Groundwater Application Review Summary Form

Application # G- 18835

To: Kristopher Byrd, Well Construction and Compliance Section Manager
From: Joel Jeffery, Well Construction Program Coordinator
Subject: Review of Water Right Application G-18835
Date: November 4, 2019

TO: Water Rights Section Date 10/30/2019
 FROM: Groundwater Section Joe Kemper
 SUBJECT: Application G- 18835 Supersedes review of NA
 Date of Review(s)

Figure 2. Well Location Map

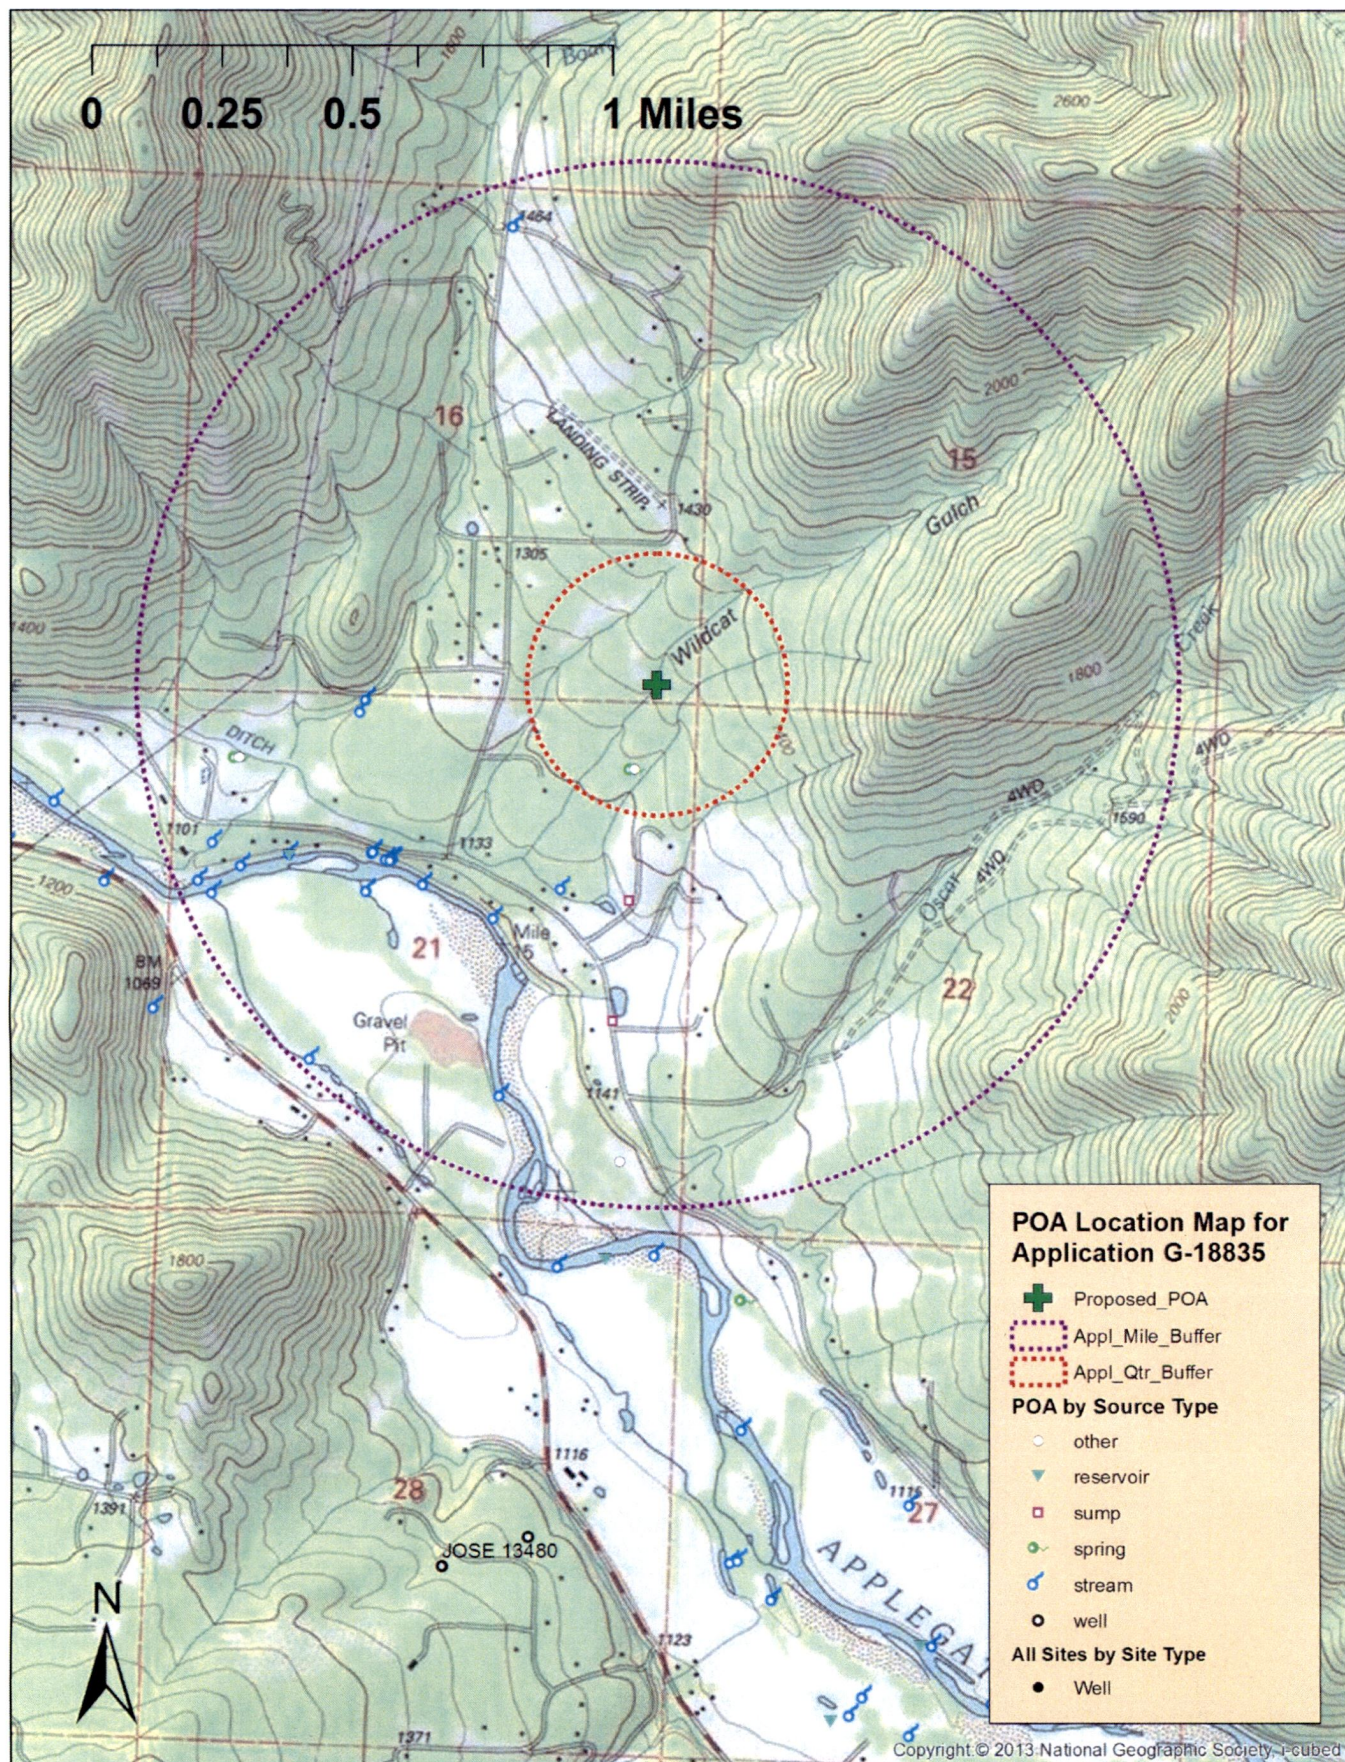
Well	Logid	Applicant's Well #	Proposed Aquifer*	Proposed Rate(cfs)	Location (T/R-S QQ-Q)	Location, metes and bounds, e.g. 2250' N, 1200' E fr NW cor S 36
1	JOSE	1	Bedrock	0.0378	37S/5W-S16 SE-SE	195' N, 475' W fr SE cor, S16
2	59952					
3						
4						
5
